# Planning and Zoning Commission

Thursday, January 9, 2025

## Crown INEOS Grenadier 24-152INF

Address	6400 Perimeter Loop Rd.
Proposal	Request for informal review and feedback on exterior renovations to an existing car dealership building prior to a formal Rezoning and Amended Final Development Plan application (AFDP)
Request	Informal review and feedback on modifications to an existing site and building.
Zoning	PCD - Planned Commerce District, Perimeter Center
Planning Recommendation	<u>Consideration of the discussion questions.</u>
Next Steps	Upon receiving feedback from the Planning and Zoning Commission (PZC), the applicant may incorporate the feedback and submit for Rezoning and AFDP.
Applicant	Vince DeStefano, archall architects
Case Manager	Rati Singh, Assoc. AIA, Planner I (614) 410-4533 <a href="mailto:rsingh@dublin.oh.us">rsingh@dublin.oh.us</a>

*Proposed improvements*

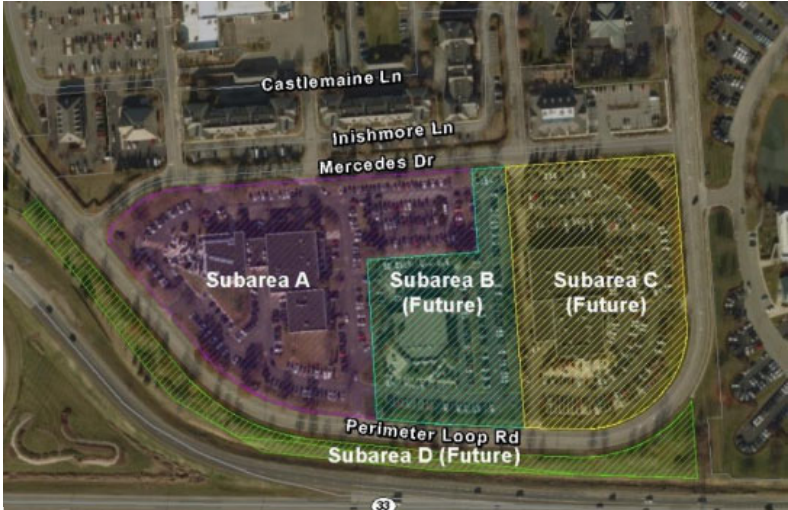
- Modifications to the existing landscaped area facing Perimeter Loop Rd to allow for a display area.
- Removal of the existing zig-zag glass facades facing the Perimeter Loop Rd with and replacement with a flat glass façade.
- Construction of a new cantilevered canopy system using metal panels, vinyl wood paneling, and angle metal supports
- Painting of existing brick masonry on the entire building.
- Refacing of the existing ground sign and installation of a new building-mounted sign.

The applicant proposes to modify the existing zig-zag façade by replacing it with a flat glass wall to create functional internal spaces. Additionally, a new cantilevered canopy system is proposed. This canopy will extend from the roof and be supported by two columns, providing a display area underneath it.

The canopy is proposed to be clad with black metal panels, with vinyl wood paneling and recessed lighting on its underside. Vinyl wood paneling would also surround the new storefront glass. The angled support columns would be painted red. In addition, the applicant is proposing to paint the existing tan brick on the building black to match the canopy.

The development text for Crown Campus PUD allows for contemporary and modern designs with a mix of materials, including brick, glass, metal, ACM, EIFS, and concrete. While glass and metal are permitted materials, the proposed vinyl wood paneling would require text modification. In general, masonry materials approved throughout the City are intended to maintain their natural composition, although the Commission has approved limited application of painted brick in the past where deemed appropriate. The adjacent Crown Eurocars (PUD-Crown Campus, Subarea A) building was approved with architectural modifications and uses same colors and similar patterns; however the brick façade was left unpainted.

It should also be noted that the color and shape of the canopy support columns resembles the car brand logo, which is reflected in the letter "A" on the signs. The Commission should consider whether the proposed building modifications and materials are appropriate and consistent with the intent of the Crown Campus PUD to allow for contemporary and modern designs. In doing so, the Commission should consider whether painting of the existing brick on the entire building or parts thereof is appropriate, and whether the canopy support design/color is appropriate as a unique architectural element.

*Proposed ground sign refacing*

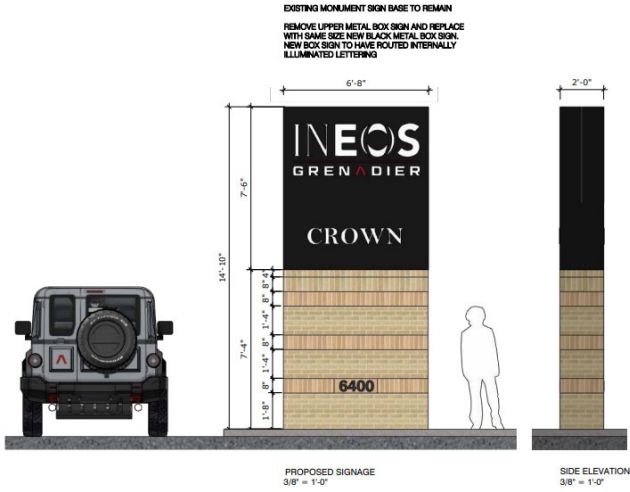
The site has an existing ground sign on Perimeter Loop Road. The applicant is proposing changes to the sign face to reflect the current branding to align with the existing Crown Eurocars sign on the adjacent campus. The applicant proposes to replace the existing blue sign face panel with black metal sign panel and 'Ineos' logo. The proposed changes do not alter the sign type nor the size.

Per the development text, all signs shall be complementary to the building. The Crown Eurocars was approved with a sign face with the same theme and colors. The Commission should consider whether the proposed new building sign and the ground sign modification are appropriate.
